CITY PLANNING COMMISSION
1231 "I" STREET, SUITE 200, SACRAMENTO, CA 95814

- APPLICATION:**
- A. Negative Declaration;
 - B. Tentative Map to be called "Emerald Creek Estates Unit No.2" to divide 2.5± partially developed acres into 11 single family lots;
 - C. Variance to allow a 20 foot front yard setback in the R-1 zone;
 - D. Lot Line Adjustment to relocate the common property line between two parcels; and,
 - E. Subdivision Modification to establish one lot greater than 160 feet in length.

LOCATION: 6712 Lemon Hill

TENTATIVE SUBDIVISION MAP
EMERALD CREEK ESTATES UNIT NO. 2

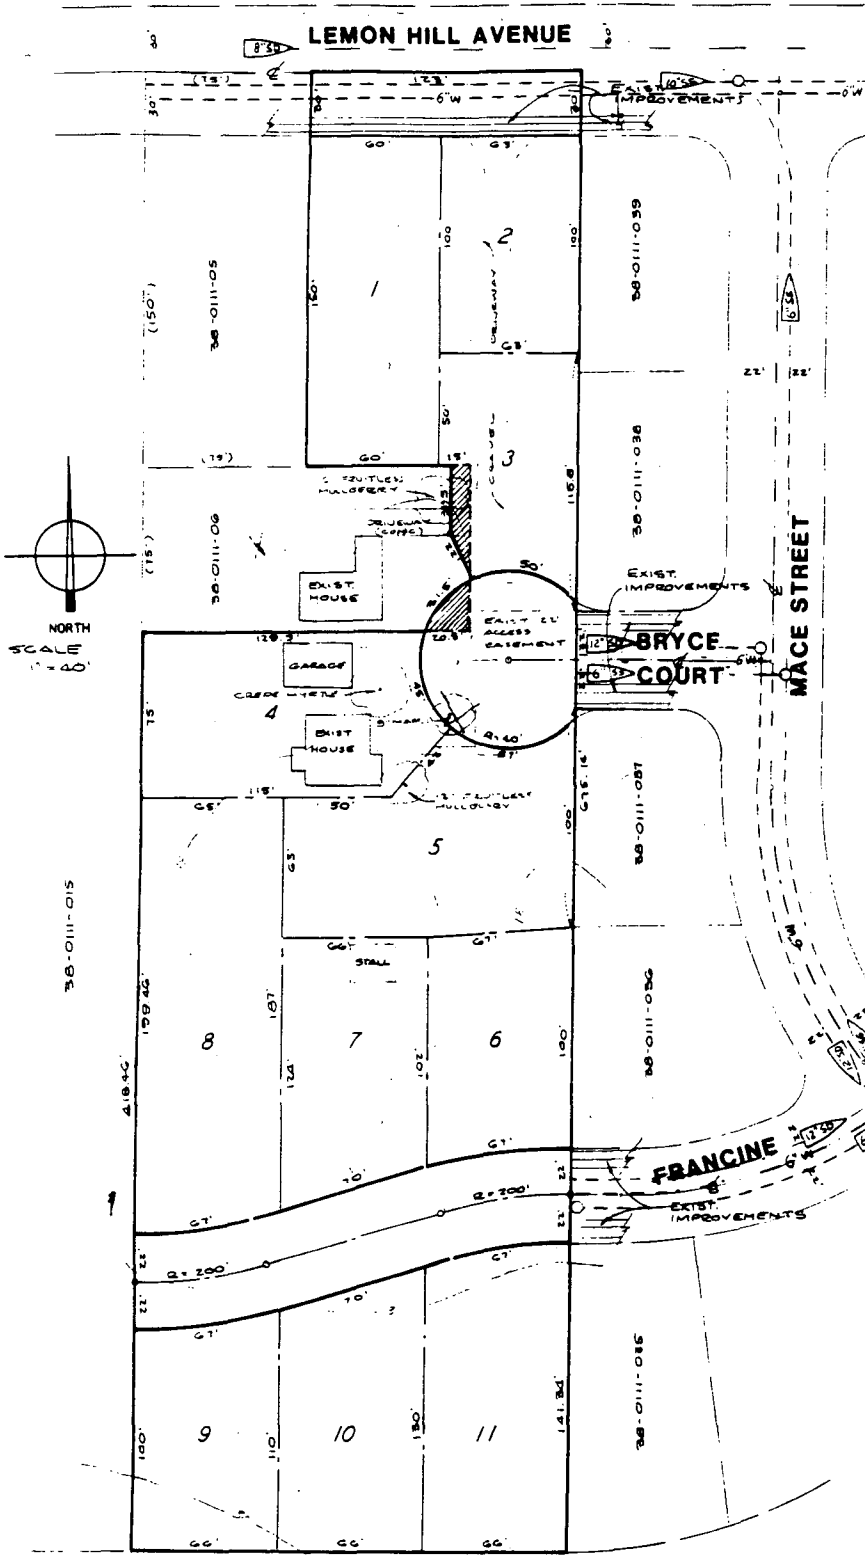
Site Design and Lot Layout- The subdivision would create 11 single family lots. The single family lots primarily range in size from 5200 to 7,000+ square feet. One parcel, however, is over 12,000 square feet in size. The larger parcel is necessary due to constraints created by existing development around the site. Although the map will create the one deep lot parcel, the overall design of the map is compatible with the General Plan, zoning and surrounding land uses.

Variance- A variance is requested to reduce the required front yard setback from 25' to 20' for an existing dwelling. As proposed, the subdivision affects two existing dwellings. One of the dwellings is within the subdivision, the other dwelling is not. Both of these dwellings will be provided new access through an extension of Bryce Court. After the construction of the cul-de-sac at the end of Bryce Court, however, one of the existing buildings will be less than the required 25 feet from its front property line. Staff supports the request for the five foot variance as adequate front yard area for the existing house is provided, and the loss of five feet should not be significant in this case. The varied setbacks may also add interest to the layout of the neighborhood.

Lot Line Adjustment- A Lot Line Adjustment is requested to alter the location of the property lines between Parcel 3 of this map and an adjacent property. The adjustment will create a more buildable Parcel 3 and will facilitate the relocation of a driveway off the new Bryce Court.

Subdivision Modification- Because of the existing development of the area and the irregular shape of the property, one parcel (number 8) will be created with a depth over the desired maximum of 160 feet. Parcel number 8 would have the potential of deep lot development, which requires approval of a special permit.

- 1. Provide standard subdivision improvements pursuant to Section 40.811 of the City Code, including necessary off-site removal and replacement of Bryce Court;
- 2. Prepare a sewer and drainage study for the review and approval of the City Engineer;
- 3. Pursuant to City Code Section 40.1302 (parkland dedication), the applicant shall submit to the City an appraisal of the property to be subdivided and pay the required parkland dedication in-lieu fees. The appraisal shall be dated not more than 90 days prior to the filing of the final map;

4. Meet all County Sanitation District requirements;
5. Submit a soils test prepared by a registered engineer to be used in street design;
6. A lot line adjustment shall be filed by certificate of compliance between APN 038-0111-006 and 008 to allow creation of lots as shown on tentative map. Certificate of compliance shall be recorded prior to final map;

7. Requires off-site dedication along Bryce Court. City will condemn at developer's expense if necessary;
8. Dedicate a 12.5-foot public utility easement for underground and overhead facilities and appurtenances adjacent to all public ways;

9. Dedicate the north 10 feet of subdivision as a public utility easement for over-head facilities and appurtenances adjacent to Lemon Hill;
10. Applicant shall provide a temporary traffic turn around at the end of Francine Drive to the satisfaction of the Fire Department;

12. Driveway for Parcel 038-0111-006 shall be relocated to access off Bryce Court;
13. Remove horse stall located on Parcel 7 prior to recordation of the final map;
